R.F. SUPPRESSION NOTES:

B-991729

241A AMPLIFIER MODIFICATION

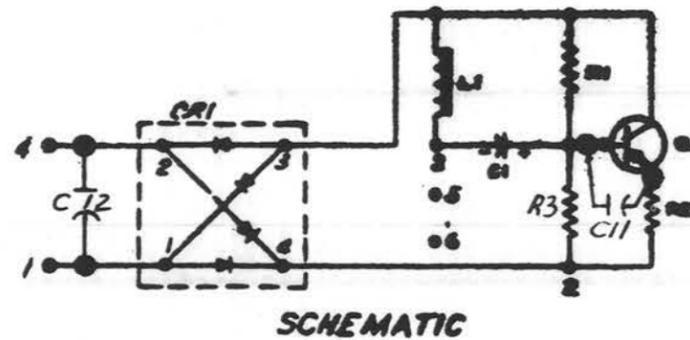
1. LOCATE (2) 0.01 uf (KS 19708-L4) CAPACITORS ON THE 241A AMPLIFIER APPROXIMATELY AS SHOWN. (C11 AND C12)
2. PLACE A, "MODIFIED FOR R.F. SUPPRESSION," LABEL NEAR THE CODE STAMP.
3. DRILL 0.025 HOLES NEAR PATHS AS SHOWN AND SOLDER CAPACITOR LEADS TO PATHS. (4 PLACES)
